DART SERVICE INSTRUCTION

TO AMEND INSTALLATION INSTRUCTIONS D350-567 REV. D OR EARLIER
AND INSTRUCTIONS FOR CONTINUED AIRWORTHINESS ICA-D350-567 REV. 1 OR EARLIER

REF CANADIAN STC: SH92-18

1.0 Purpose

Figure 1. Floor Window Close-out Kit Installation

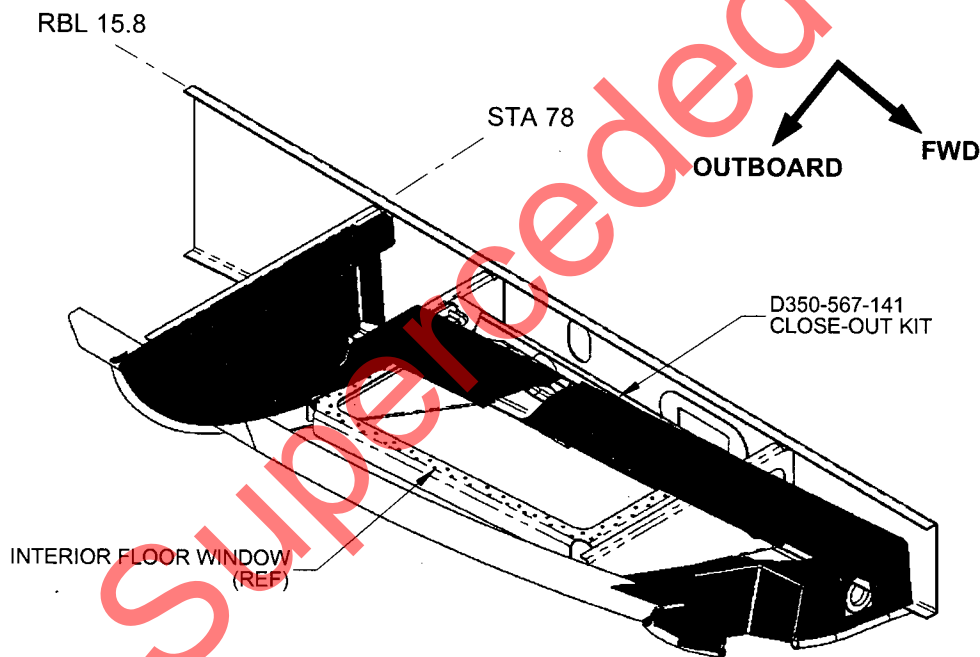
The purpose of this service instruction is to add the D350-567-141 Close-out Kit, which is intended for customers wishing to operate their aircraft with the interior floor window removed. The D350-567-141 Floor Window Close-out Kit provides a barrier around the interior and exterior vertical reference floor window to prevent objects from falling into the aircraft controls when the interior floor window is removed as shown in Figure 1.

Figure 2. Floor Window Close-out Kit Installation

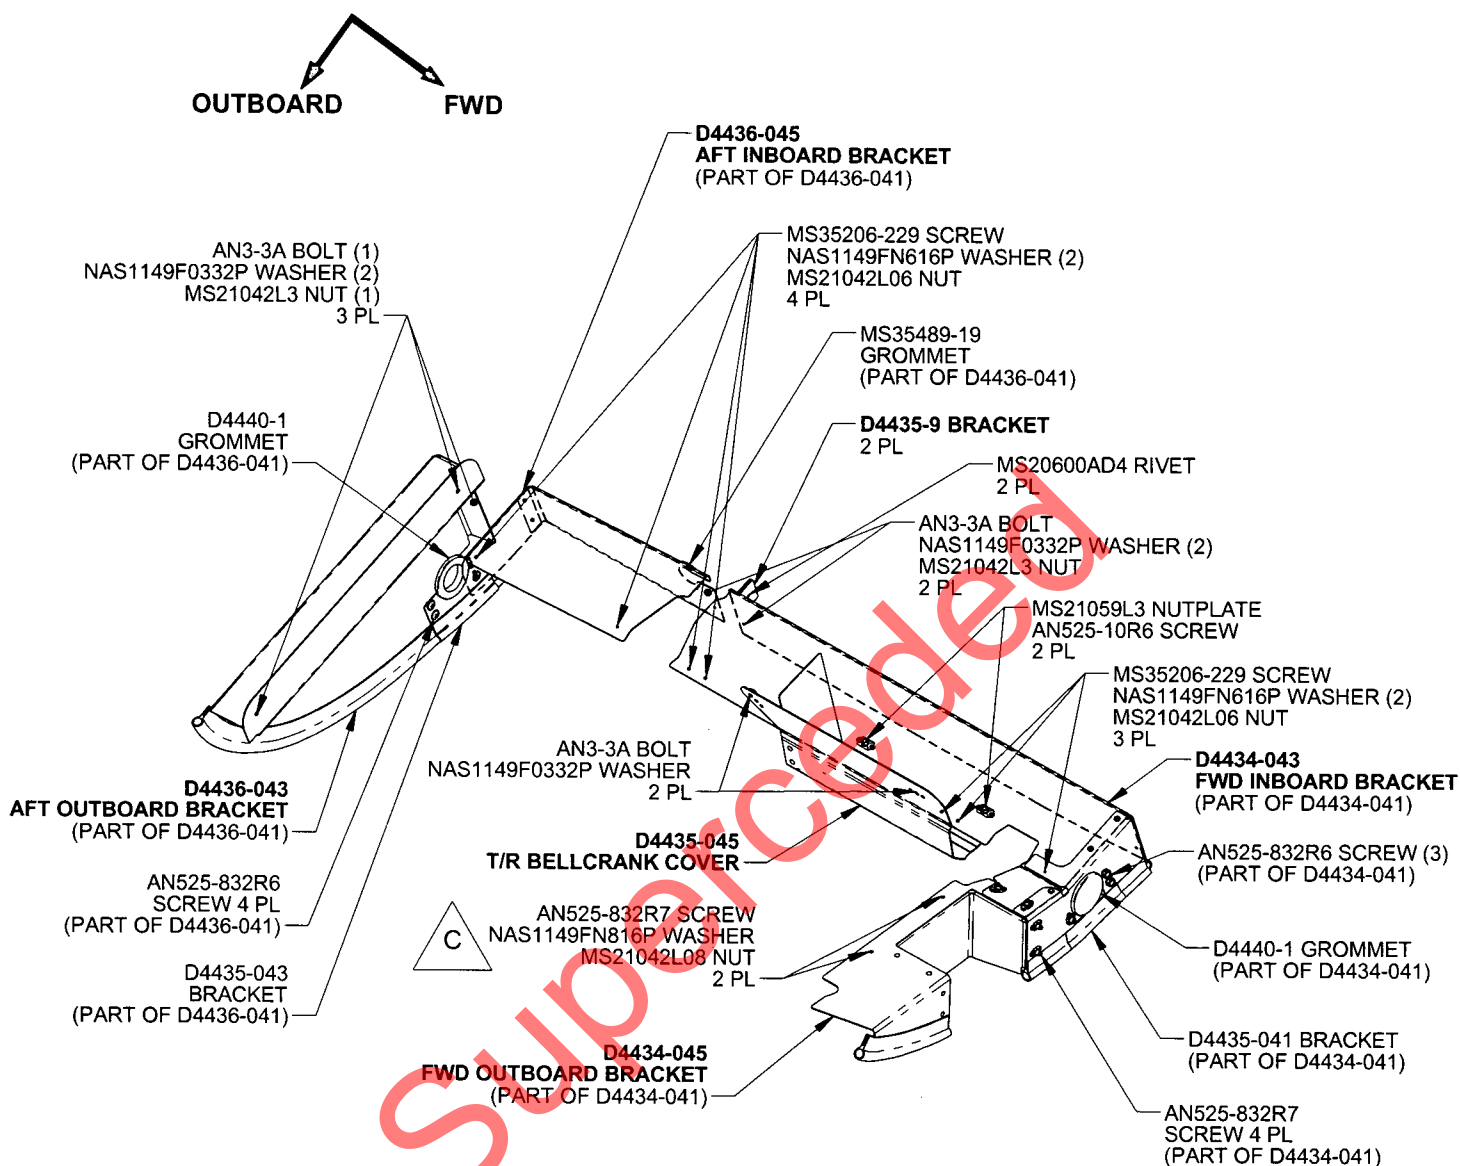
- Figure 2 shows the general arrangement and installation of the D350-567-141 Close-out Kit. The procedure that follows outlines the step-by-step procedures for installing the kit with reference photos from the initial installation.
- In conjunction with this modification, it is acceptable to remove the interior floor windows as applicable. Note that the structural reinforcement around the window opening is still required.
 - D350-567-115 — OK to remove D3295-041
 - D350-567-031 — OK to remove D3212-1
 - D350-567-011 — OK to remove D2214
 - D350-567-021 — OK to remove D2951
- It is acceptable to drill/trim the D350-567-141 Close-out Kit as required to improve fit.

Figure 3. D4436-043 Aft Outboard Bracket Installation

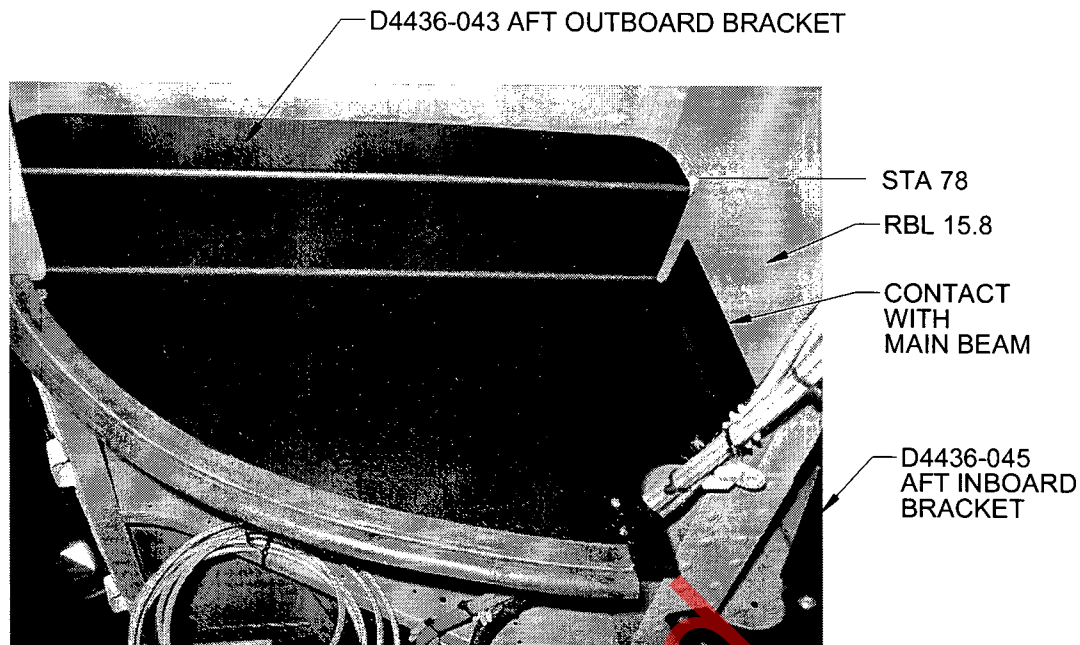
- 4.1 Temporarily install D4436-043 Aft Outboard Bracket and D4436-045 Aft Inboard Bracket using clecos and/or clecos clamps. Before drilling holes:
- Position the D4436-043 Aft Outboard Bracket so the flange contacts the main beam as shown in Figure 3.

Figure 4. D4436-043 & D4435-043 Brackets Installation

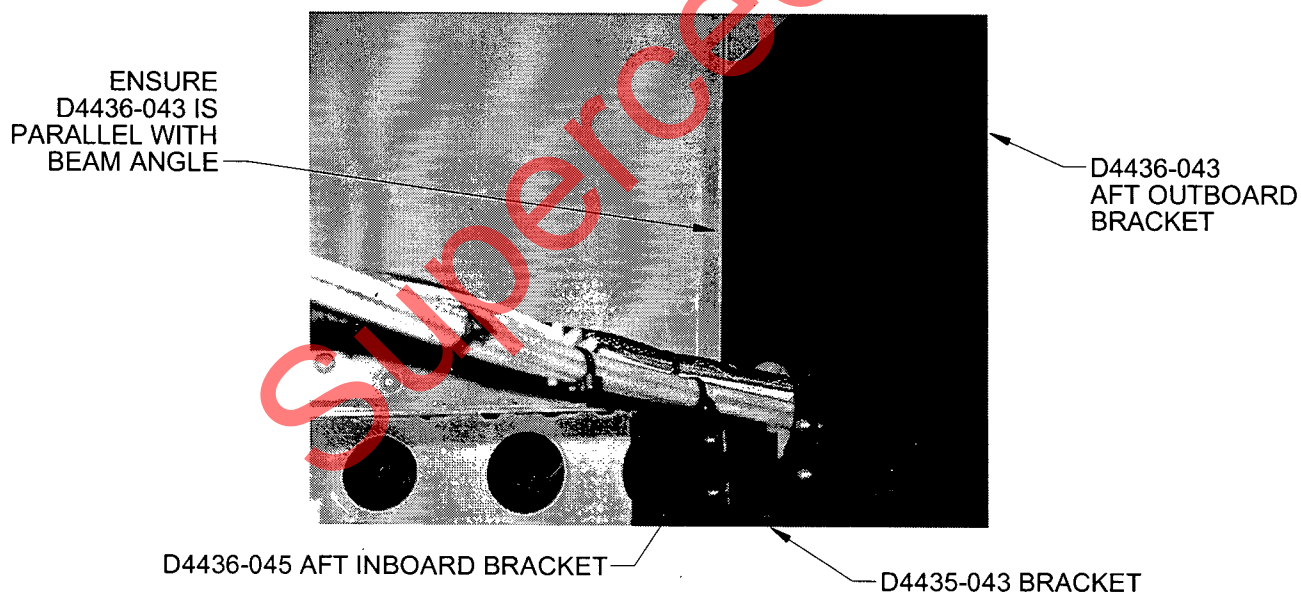
- Confirm that the D4436-043 Aft Outboard Bracket and beam angle are parallel as shown in Figure 4.
- 4.2 Temporarily install D4434-043 Fwd Inboard Bracket and D4434-045 Fwd Outboard Bracket using clecos and cleco clamps. Confirm there is no contact between D4436-045 Aft Inboard Bracket and D4434-043 Fwd Inboard Bracket and main beam gusset as shown in Figure 5.

Figure 6. D4436-043 & D4436-045 Brackets Installation

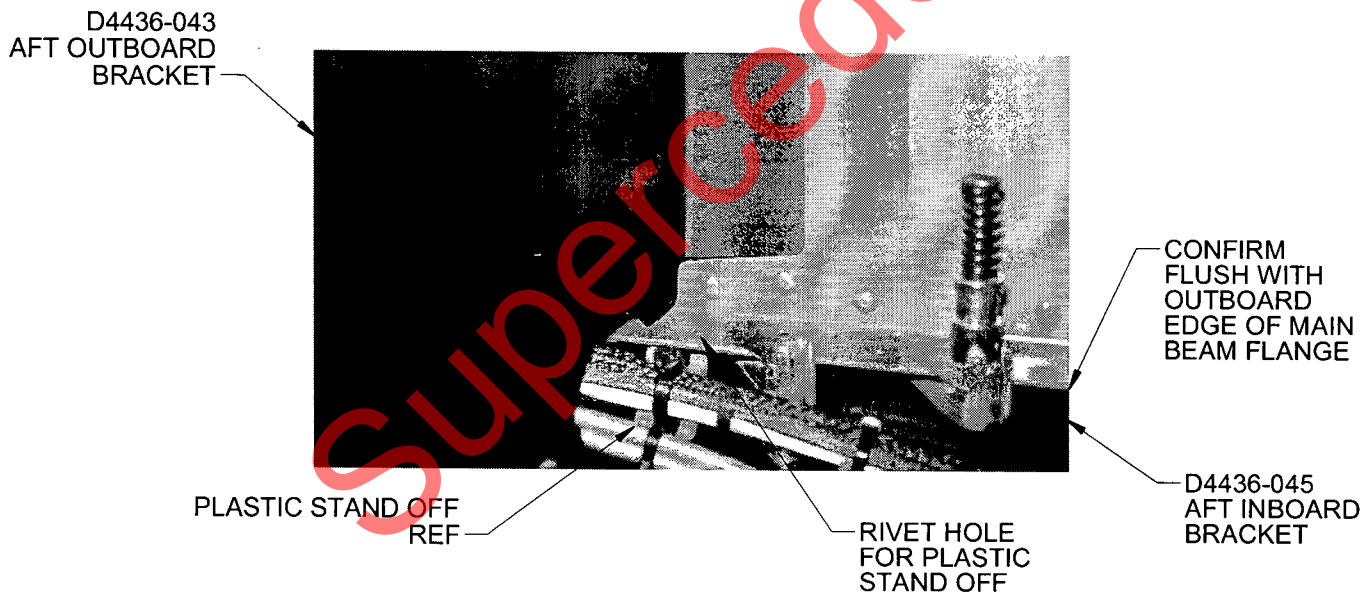
- 4.4 Drill off rivets holding plastic wire bundle stand offs. Transfer drill $\varnothing 0.144$ holes to D4436-045 Aft Inboard Bracket per Figure 6. Transfer drill 2 x $\varnothing 0.144$ holes to D4434-043 Fwd Inboard Bracket per Figure 7. Transfer drill 2 x $\varnothing 0.144$ holes for D4434-043 Fwd Inboard Bracket per Figure 8. Before drilling confirm the D4434-043 and D4436-045 brackets are flush with outboard edge of main beam flange. Assemble D4436-045 Aft Inboard Bracket and D4434-043 Fwd Inboard Bracket and wire bundle stand offs to main beam flange using MS35206-229 screw, NAS1149FN616P washer and MS21042L06 nut.

Figure 7. D4434-043 & D4436-045 Brackets Installation

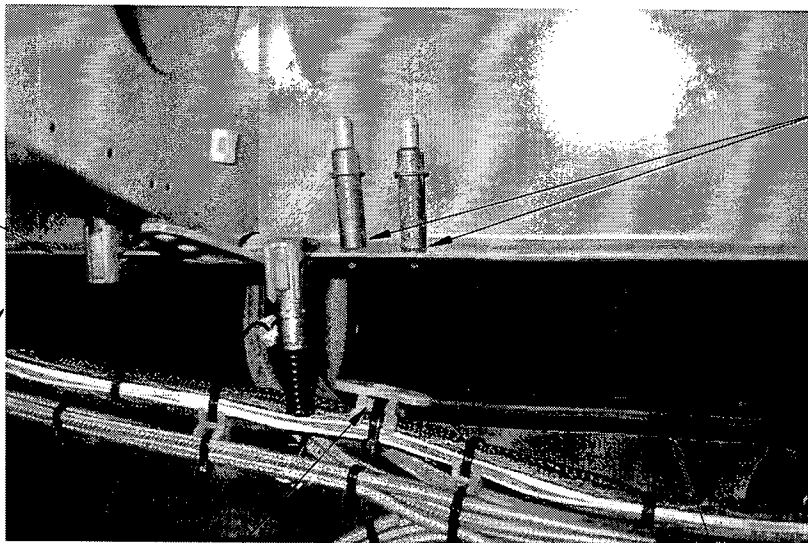
CONFIRM
FLUSH WITH
OUTBOARD
EDGE OF MAIN
BEAM FLANGE

Figure 10. D4434-043 and D4435-9 Brackets Installation

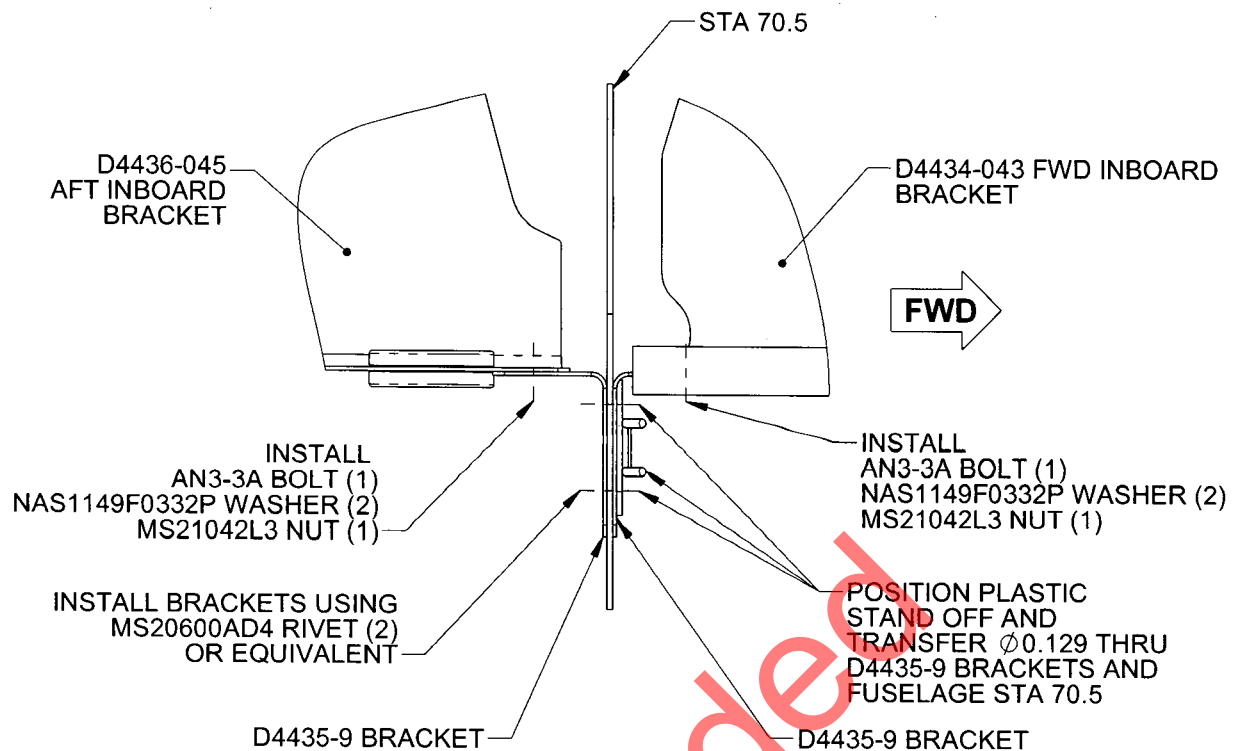
- 4.5 Install D4436-043 Aft Outboard Bracket using AN3-3A bolt and NAS1149F0332P washer and MS21042L3 nut per Figure 9.
- 4.6 Remove 2 rivets holding RH heating plastic stand off as shown in Figure 10. Position the D4435-9 Brackets on the in/outboard sides of the cross beam and transfer drill 2 x $\varnothing 0.129$ holes from crossbeam to both D4435-9 Brackets. Install D4435-9 Brackets and RH heating plastic stand off using MS20600AD4 rivets or equivalent.

- 4.7 Drill a pilot hole from D4435-9 Bracket to the D4434-045 Fwd Inboard Bracket and D4436-045 Aft Inboard Bracket and open to $\varnothing 0.191$. Install AN3-3A bolt, NAS1149F0332P washer and MS21042L3 nut as shown in Figure 10. Be sure to maintain edge distance.

Figure 11. D4434-045 Bracket Installation

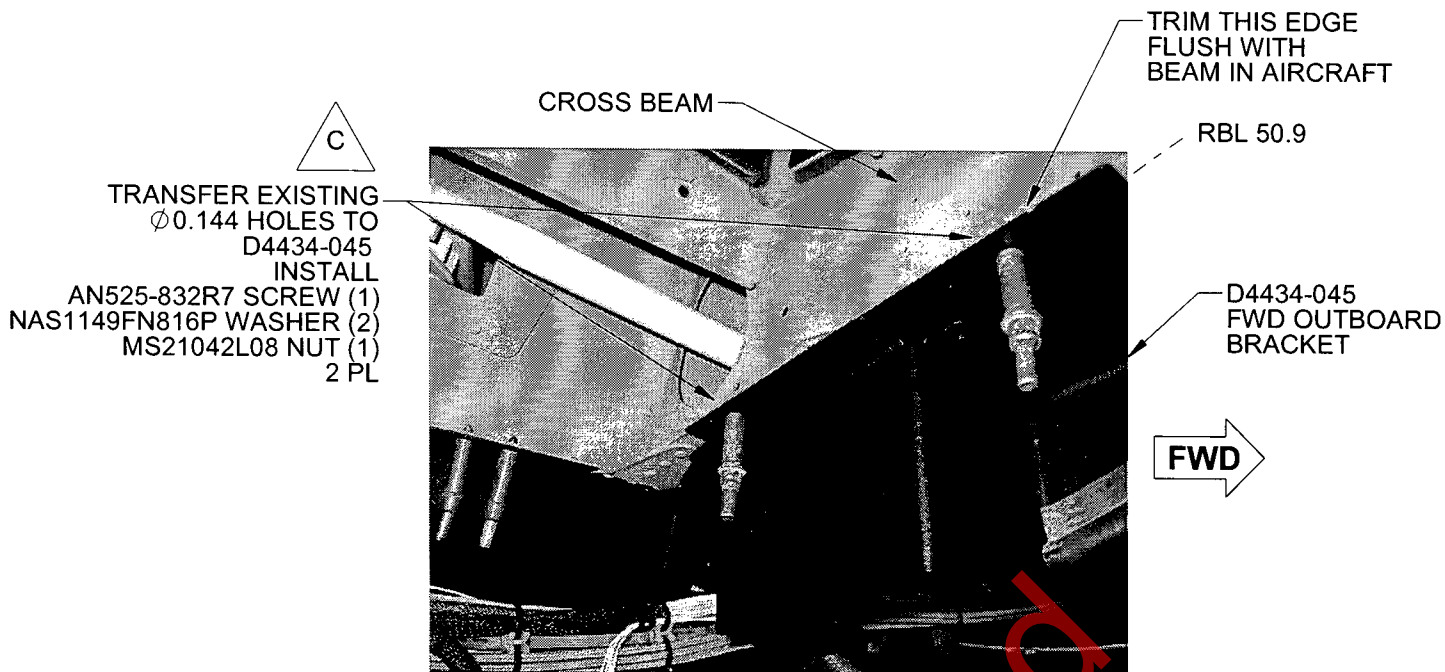
- 4.8 Transfer drill 2 x $\varnothing 0.144$ holes from crossbeam to D4434-045 Fwd Outboard Bracket if holes exist in crossbeam. If holes do not exist, drill 2 x $\varnothing 0.144$ holes at either end of D4434-045 bracket as shown in Figure 11. Install AN525-832R7 Screws, NAS1149FN816P washer and MS21042L08 nuts.

Figure 12. D4435-045 T/R Bellcrank Cover Installation

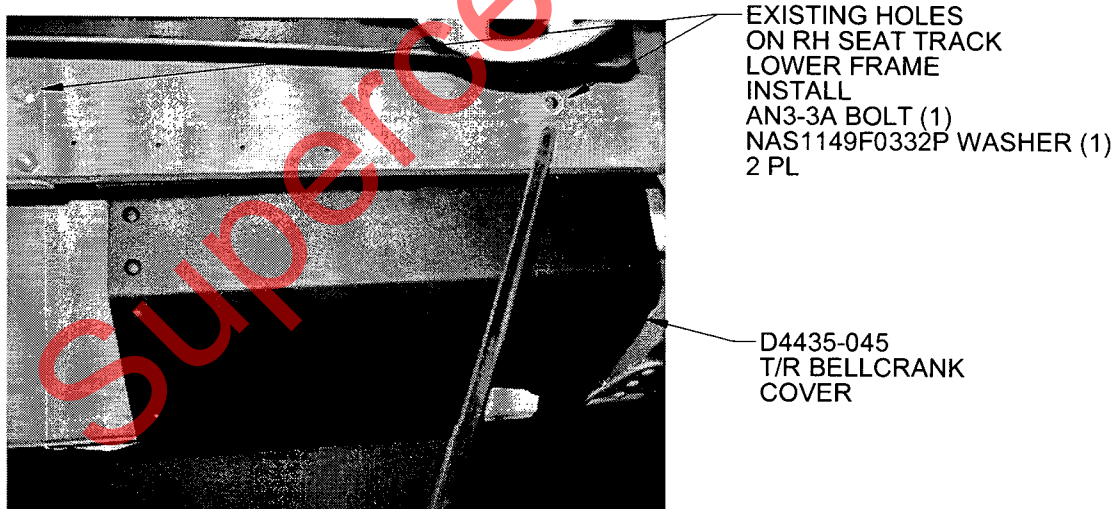
- 4.9 Align D4435-045 T/R Bellcrank Cover with existing holes in RH seat track lower frame and temporarily install using clecos and/or cleco clamps as shown in Figure 12.

- 4.10 Transfer drill 2 x $\varnothing 0.098$ holes from D4435-045 T/R Bellcrank Cover to D4434-043 Fwd Inboard Bracket. Open holes to $\varnothing 0.191$ and install MS21059L3 nut plate into D4434-043 Fwd Inboard Bracket as shown in Figure 12 and Figure 13. Install D4435-045 T/R Bellcrank Cover using AN525-10R6 screw, AN3-3A bolt and NAS1149F0332P washer per Figure 12 and Figure 13.

Figure 13. D4435-045 & D4434-047 Cover Installation

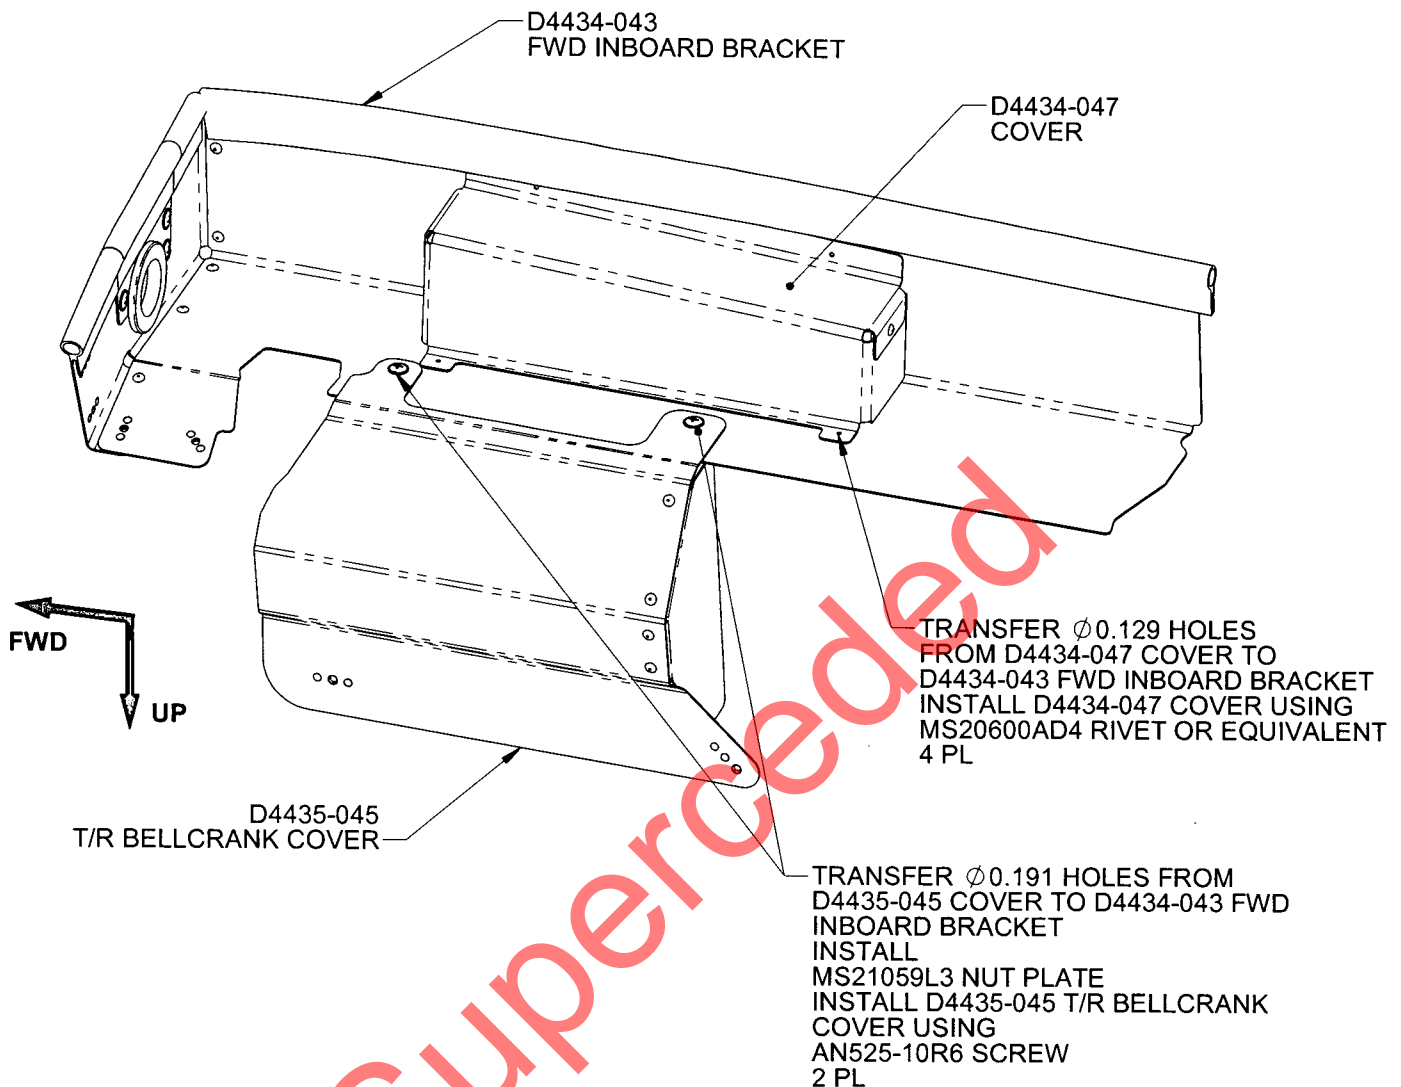
- 4.3 If aircraft is equipped with Collective Circuit Breaker Board box trim D4434-043 Fwd Inboard Bracket as shown in Figure 14. Install D4434-047 Cover as shown in Figure 13. Note: Confirm the D4434-047 Cover fits over the Collective Circuit Breaker Board box. Adjust opening as required.
